UNITED STATES PATENT AND TRADEMARK OFFICE

APPLICATION NO.	FILING DATE	FIRST NAMED INVENTOR	ATTORNEY DOCKET NO.	CONFIRMATION NO.
09/687,600	10/12/2000	Jason E. Tripard	MI22-1550	2568
21567	7590	11/30/2004	EXAMINER	
WELLS ST. JOHN P.S. 601 W. FIRST AVENUE, SUITE 1300 SPOKANE, WA 99201			CHOI, STEPHEN	
			ART UNIT	PAPER NUMBER
			3724

Office Action Summary	Application No. 09/687,600	Applicant(s) TRIPARD, JASON E.	
	Examiner Stephen Choi	Art Unit 3724

DETAILED ACTION

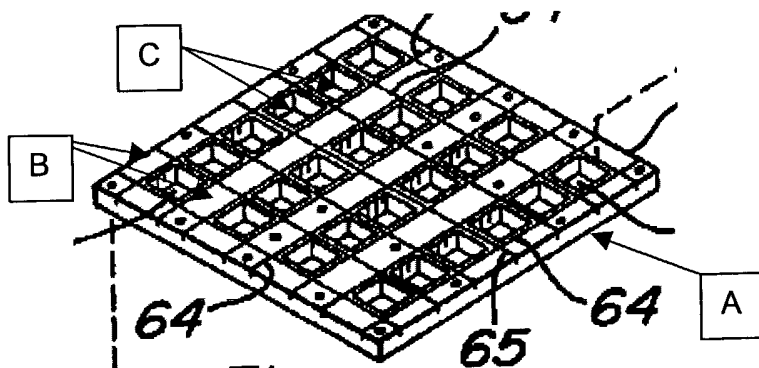
- a) a panel having an uppermost surface and molded as part of the separator (A, Figure below);
- b) a plurality of blocks (B, Figure below) as one piece with the panel and extending upward from the uppermost surface of the panel creating a recessed portion (C, Figure below) on the panel wherein the entirety of the recessed portion is directly over the uppermost surface of the panel;
- c) a cutting mechanism.

Regarding claim 112, an actuator (78)

The examiner respectfully disagrees. The recessed portion is a portion between the blocks (labeled as element B on the figure above) which terminates at the uppermost surface of the panel (labeled as element A on the figure above) such that the

entirety of the recessed portion is directly over the uppermost surface of the panel. The claim does not preclude the recessed portion having an open bottom.
